From: BRYAN Martin (EXTERNAL AREVA) [Martin.Bryan.ext@areva.com]
Sent: Tuesday, October 19, 2010 8:03 AM
To: Tesfaye, Getachew
Cc: Hearn, Peter; KOWALSKI David (AREVA)
Subject: FW: DRAFT RESPONSES FOR FSAR Chapter 9 Weekly NRC Telecon
Attachments: Blank Bkgrd.gif; DRAFT RESPONSE RAI 351 Q.09.02.05-28.pdf; DRAFT FSAR Changes RAI 351 Q.09.02.05-23.pdf; DRAFT FSAR Changes RAI 351 Q.09.02.05-25 (Parts 1-3, 8).pdf; DRAFT FSAR Changes RAI 351 Q.09.02.05-28.pdf; DRAFT FSAR Insert RAI 351 Q.09.02.05-25 (Parts 1-3, 8).pdf; DRAFT RESPONSE + FSAR Changes RAI 351 Q.09.02.05-32 (Orig. 2c).pdf; DRAFT RESPONSE RAI 351 Q.09.02.05-23.pdf; DRAFT RESPONSE RAI 351 Q.09.02.05-25 (Parts 1-3, 8).pdf

Please transmit to Getachew Tesfaye the attached partial set of DRAFT responses to RAI 351 questions. These responses will be discussed at today's (10/19/10) FSAR Chapter 9 Weekly Telecon/GoToMeeting with the NRC.

Question 09.02.05-28:**Follow-up to RAI 175, Question 9.2.5-11:**

Question 09.02.05-23:**Follow-up to RAI 175, Question 9.2.5-05:**

Figure 2.7.11-1—Essential Service Water System Functional Arrangement
Sheet 1 of 9

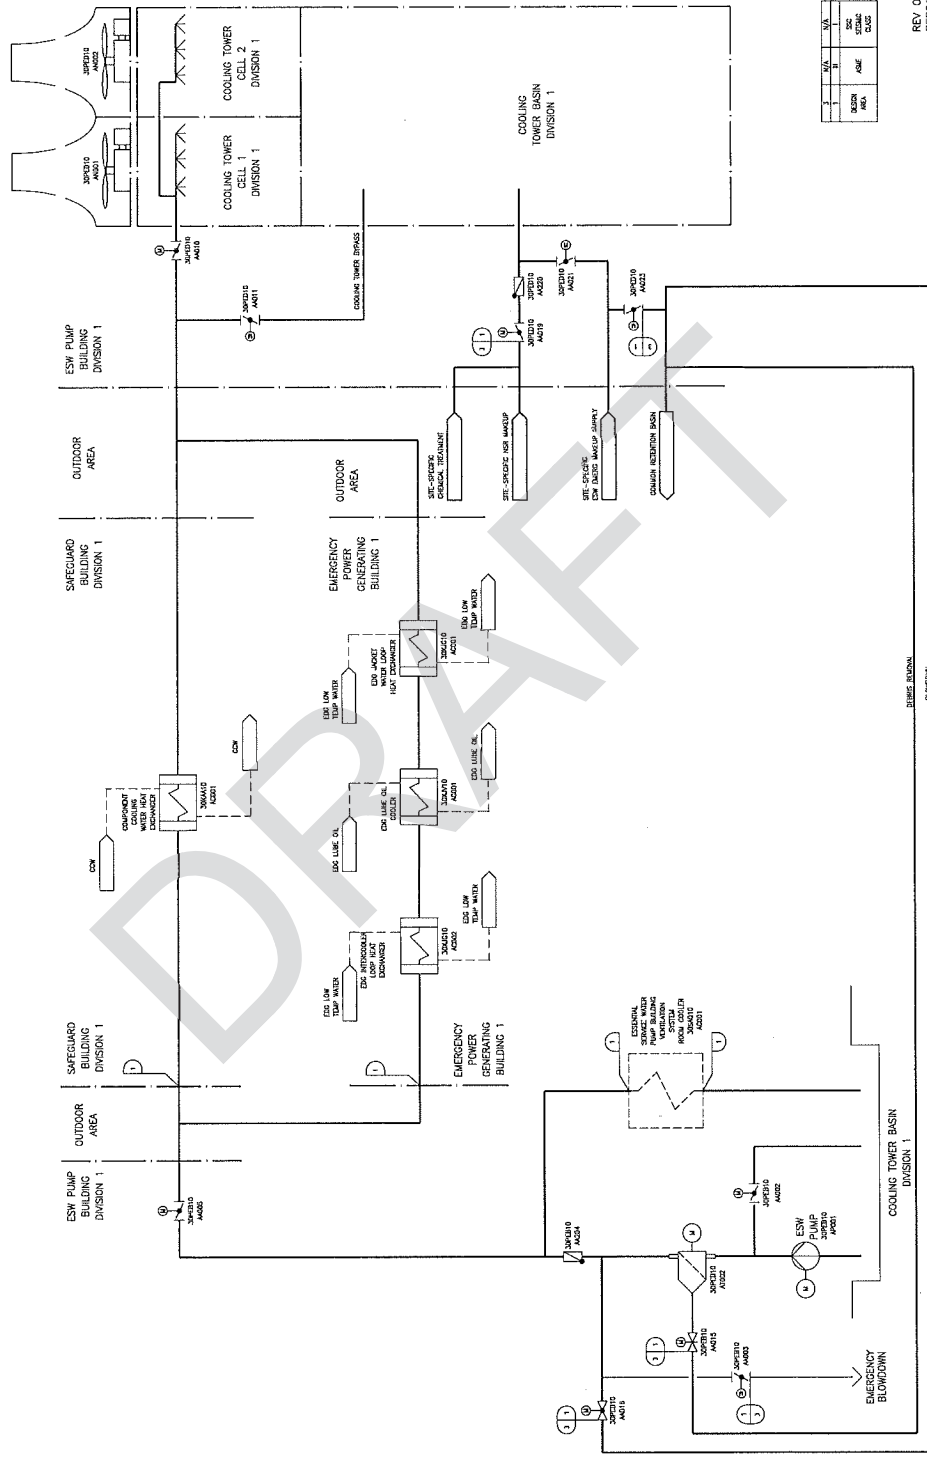
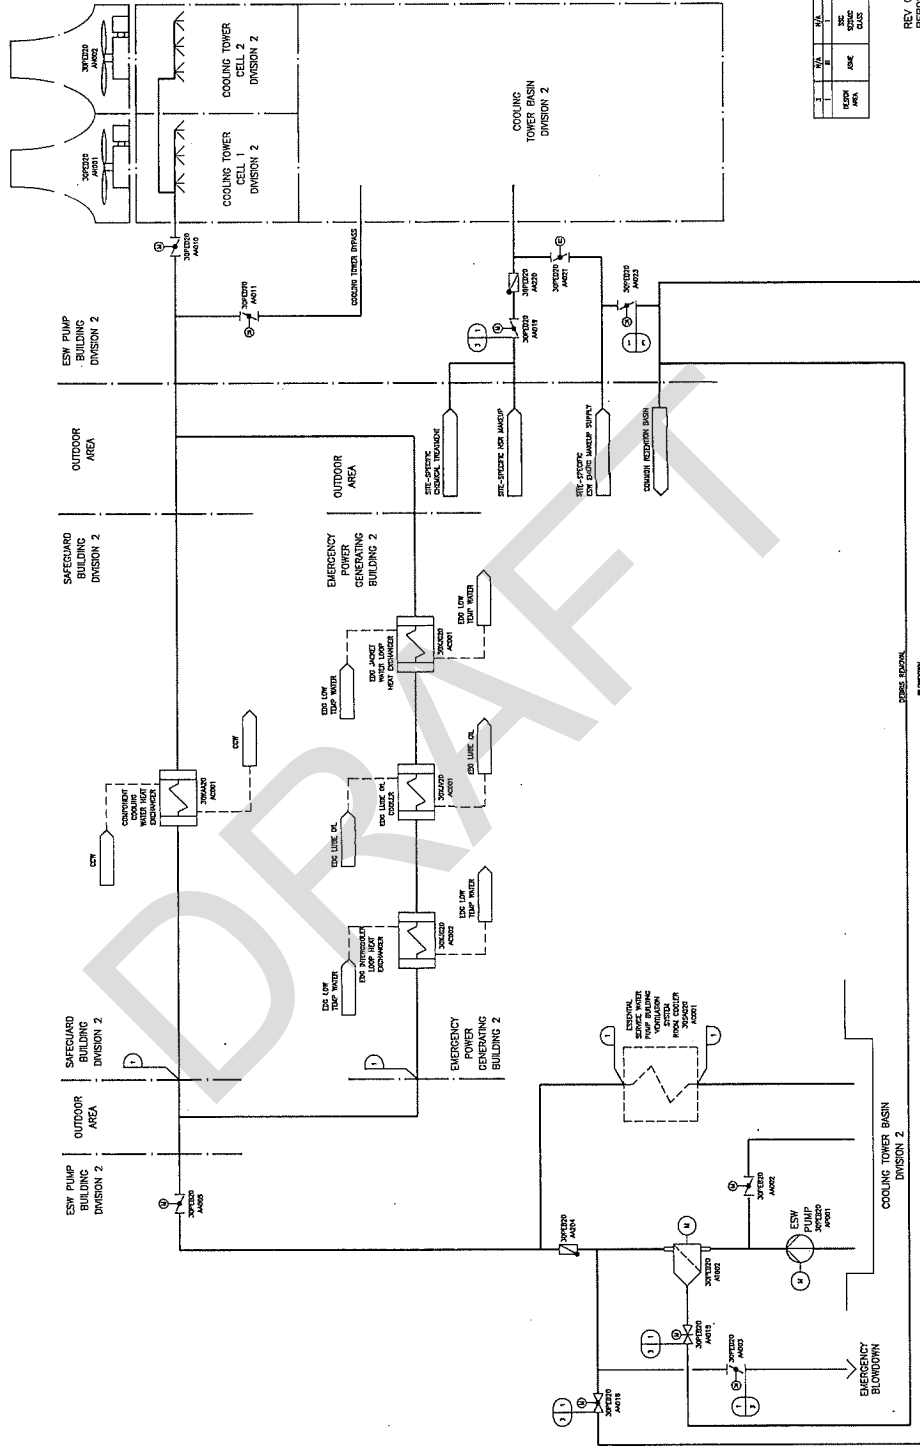
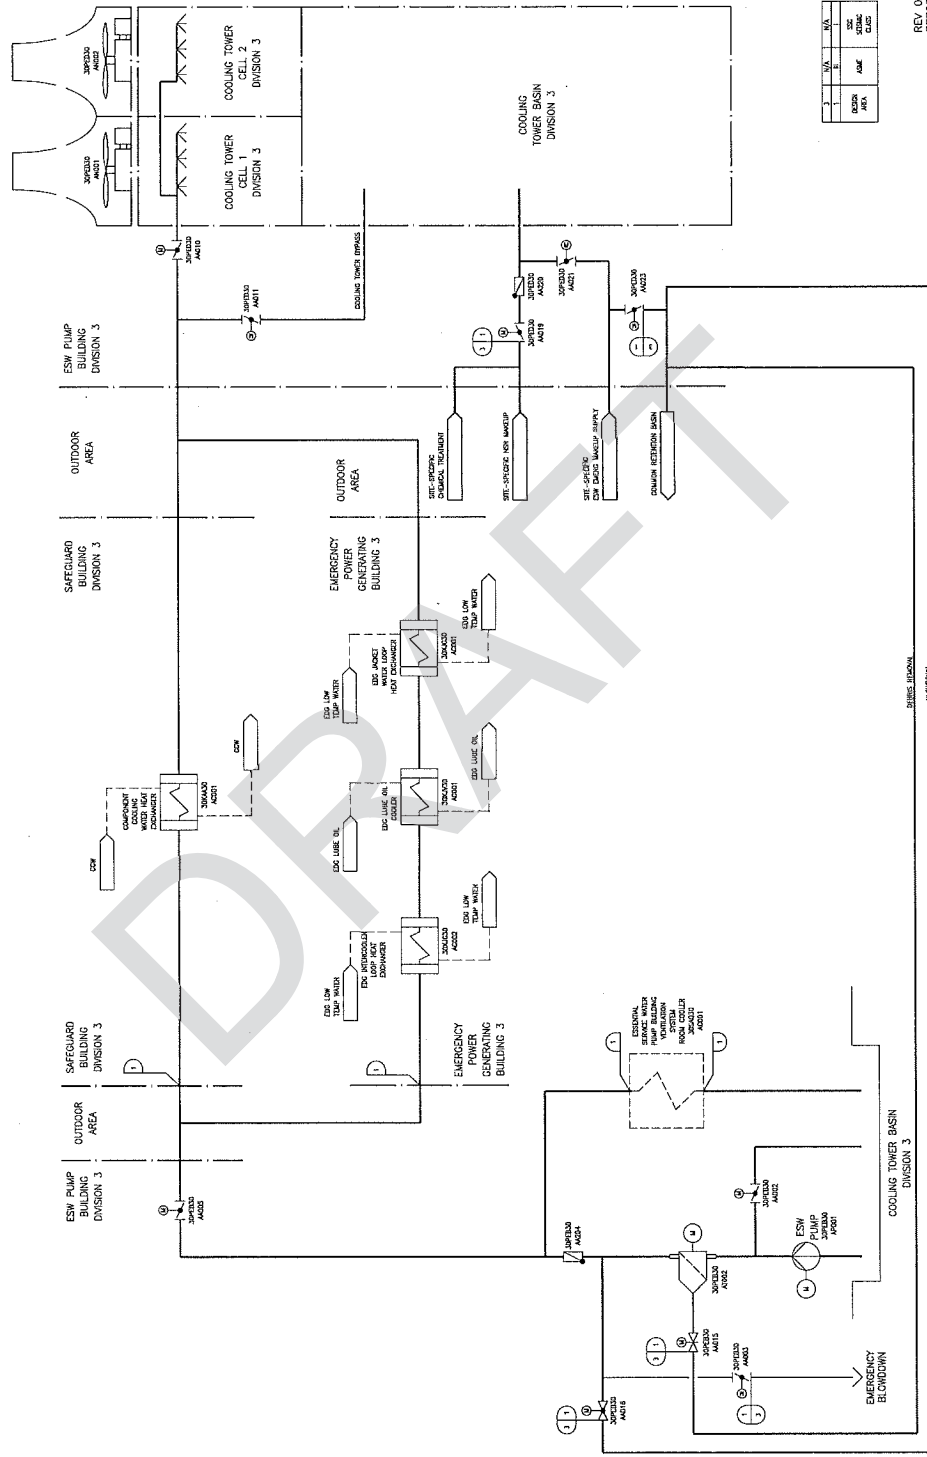
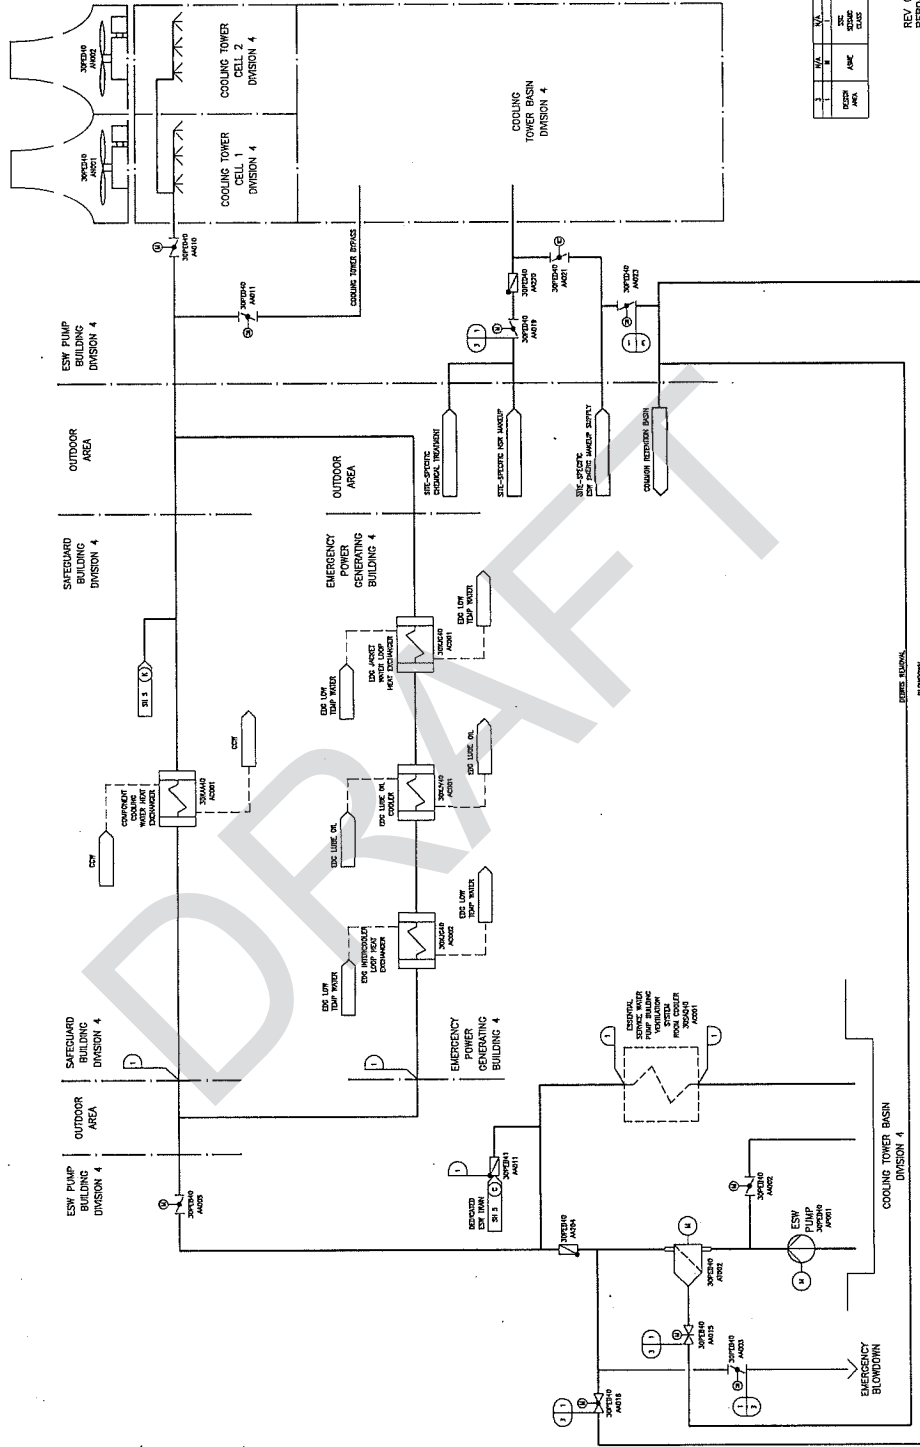
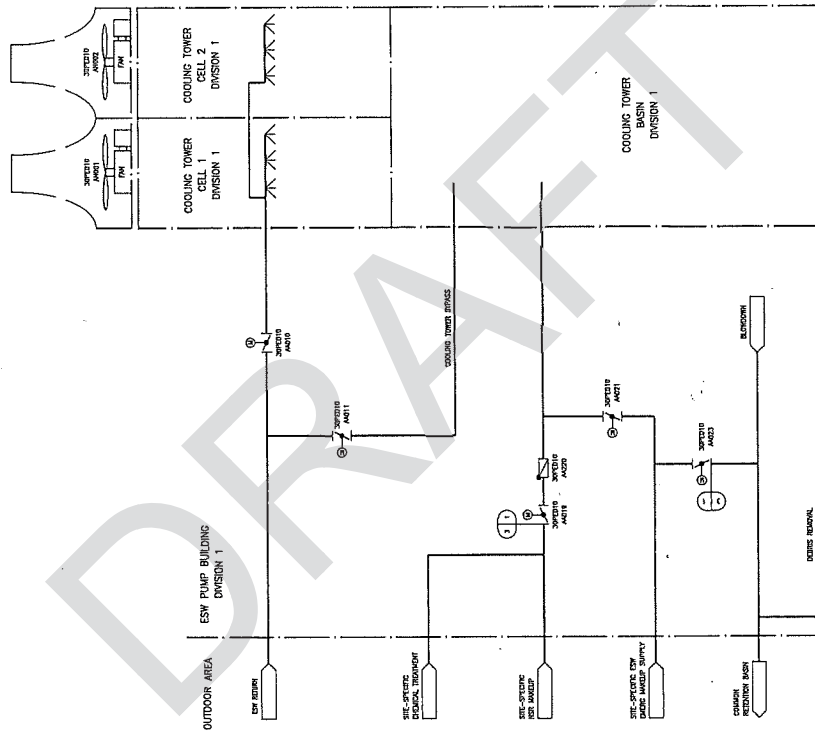
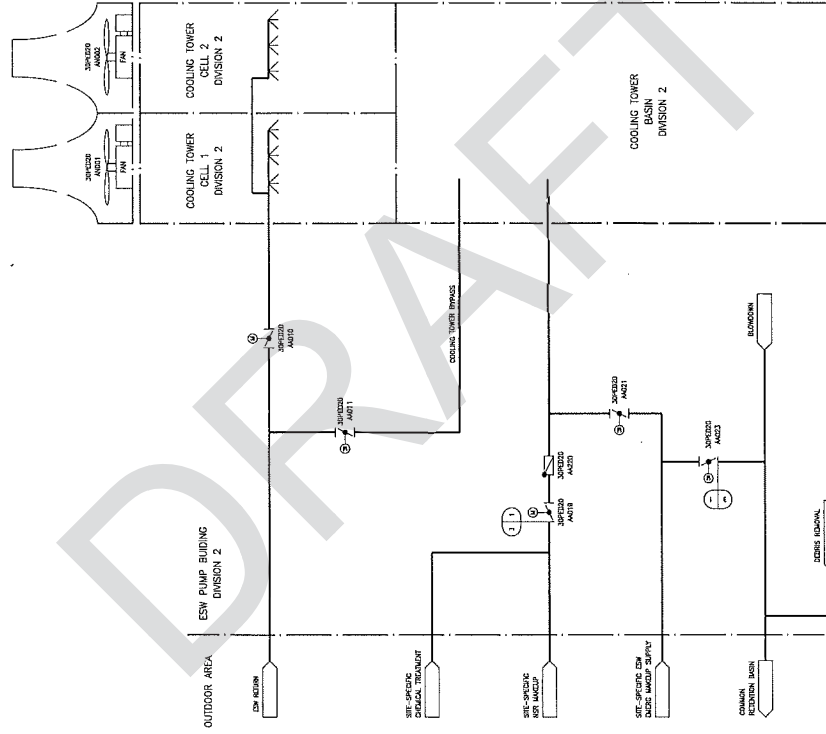
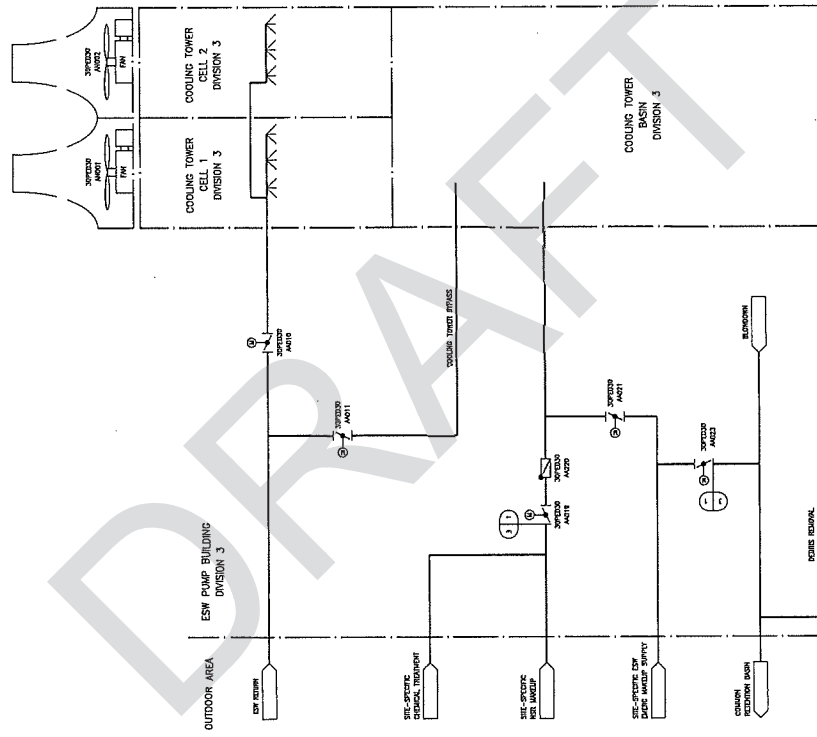
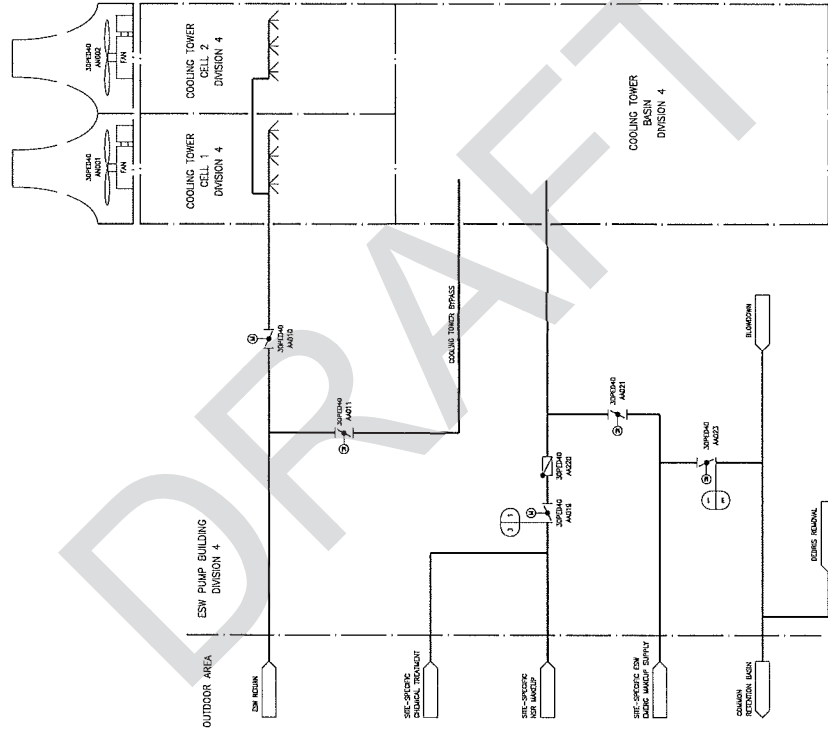
The applicant's response for Items (d) and (g) refer to Tier 2 FSAR Section 9.2.1 for information pertaining to certain UHS valves and instruments. The description and piping and instrumentation diagram for the UHS should show those items that are part of the UHS and Tier 2 FSAR Section 9.2.5 should address these items accordingly. Likewise, Tier 2 FSAR Section 9.2.1 should describe and address those items that are designated as part of the essential service water system. Consequently, Tier 2 FSAR Sections 9.2.1 and 9.2.5 and associated figures need to be revised to clearly indicate which items are included within their respective scopes and to describe those items accordingly. The following additional items are also related to this issue:

UHS Makeup Water Test Isolation Valves 30PED10/20/30/40AA023 and the associated cross-connect line are removed from U.S. EPR FSAR Tier 1, Figure 2.7.11-1 Sheets 1-4 and Sheets 6-9 and U.S. EPR FSAR Tier 2, Figure 9.2.5-1. Valves 30PED10/20/30/40AA023 are removed from U.S. EPR FSAR Tier 2, Table 3.9-6-2. They are part of the conceptual site-specific UHS support systems as indicated in the attached markup of U.S. EPR FSAR Tier 2, Figure 9.2.5-2. The conceptual function for the valve is each valve is manually opened during surveillance testing of its UHS division.

Figure 9.2.1-1—Essential Service Water System Piping & Instrumentation Diagram Sheet 3 of 4

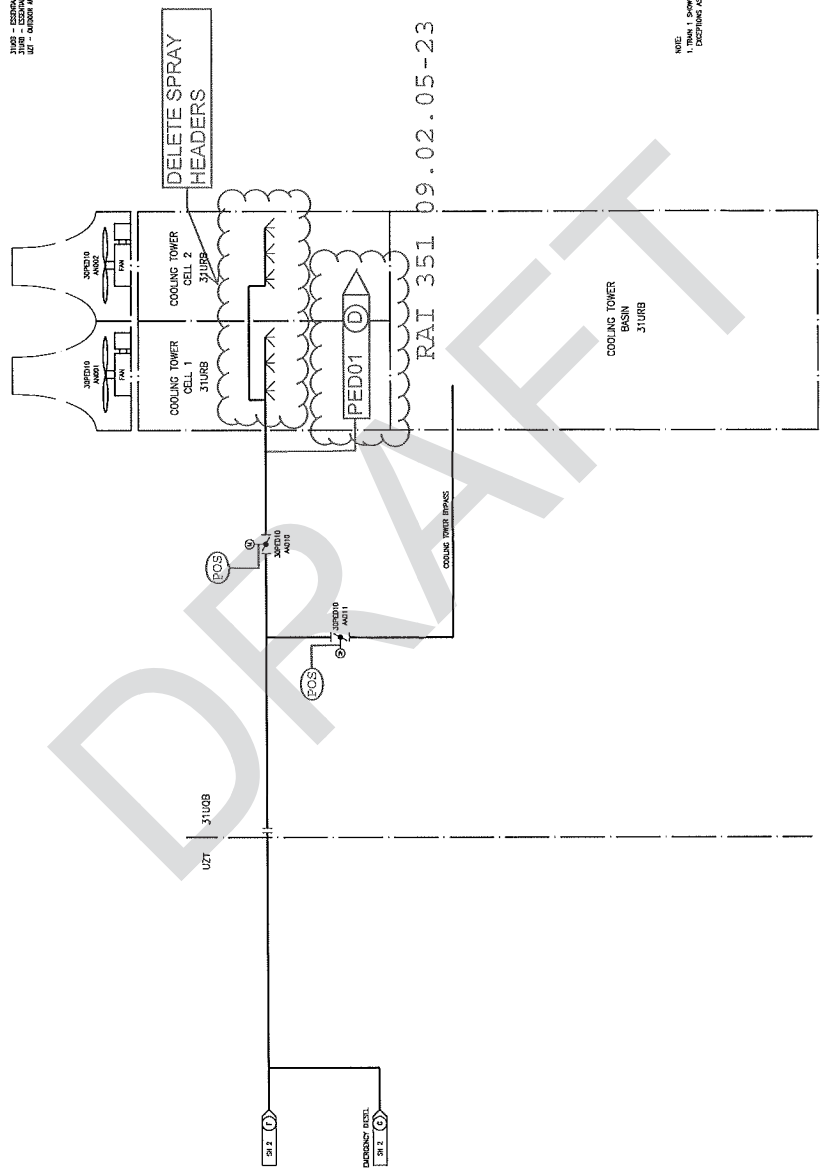
- c. FSAR Tier 2 Figure 9.2.1-1, Sheet 3, and Figure 9.2.5-1 both show that the chemical treatment system is only connected to the normal makeup system and not to the safety-related emergency makeup system. This appears to be in error and the applicant should correct or explain.

- c. This is not in error. The chemical treatment system is non-safety site specific system that provides water treatment chemicals to the normal make up water system. The chemical treatment system is not needed during emergency operation. Details related to chemical treatment for the safety-related emergency makeup system are the responsibility of the COL applicant as indicated in Tier 2 Figure 9.2.5-2.

Figure 9.2.1-1—Essential Service Water System Piping & Instrumentation Diagram
Sheet 4 of 4

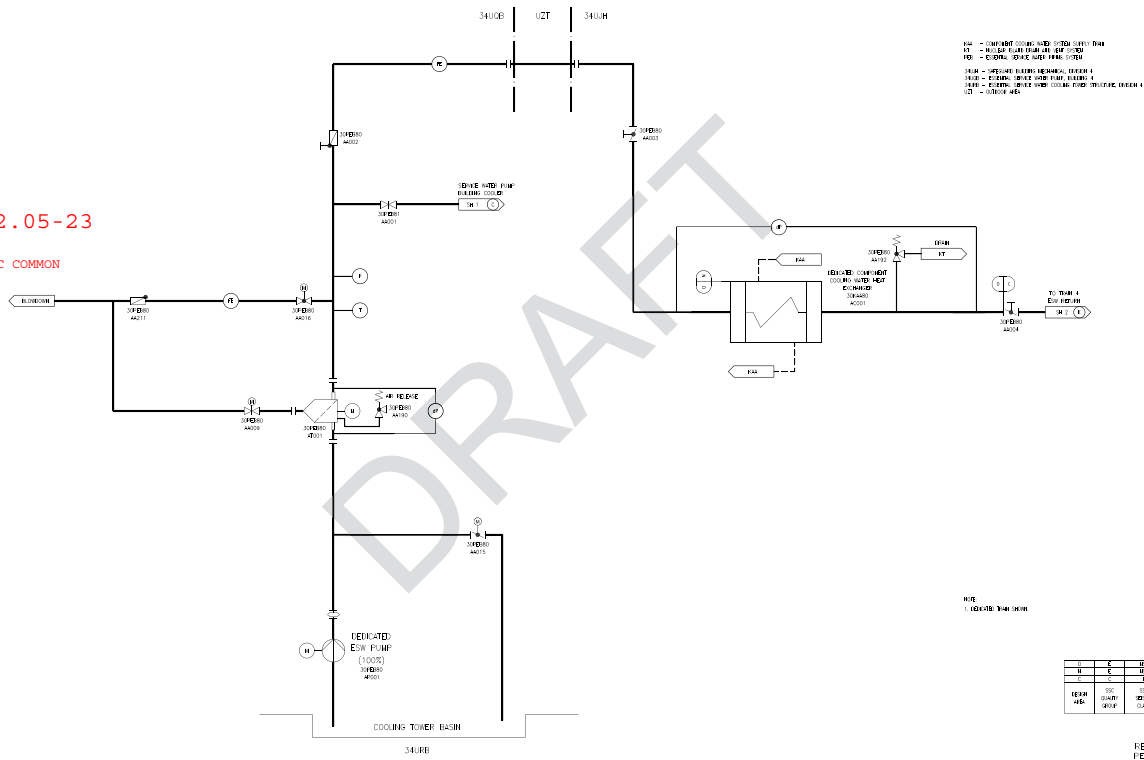
- a. Dedicated and emergency ESWS blowdown are not shown on FSAR Tier 2 Figure 9.2.5-1 as UHS support systems
- b. Interface flange connections are not shown on FSAR Tier 2 Figure 9.2.5-1 for the dedicated and emergency ESWS blowdown support system.

- b. Refer to response to RAI 351, Question 09.02.05-22, markup of U.S. EPR FSAR, Figure 9.2.1-1, Sheet 1 for additional information concerning the emergency ESWS blowdown system. U.S. EPR FSAR Tier 2, Figure 9.2.1-1 Sheet 4 will be revised to show the off-

page connection for the ESWS dedicated blowdown system to Tier 2 Figure 9.2.5-1 and the site-specific interface.
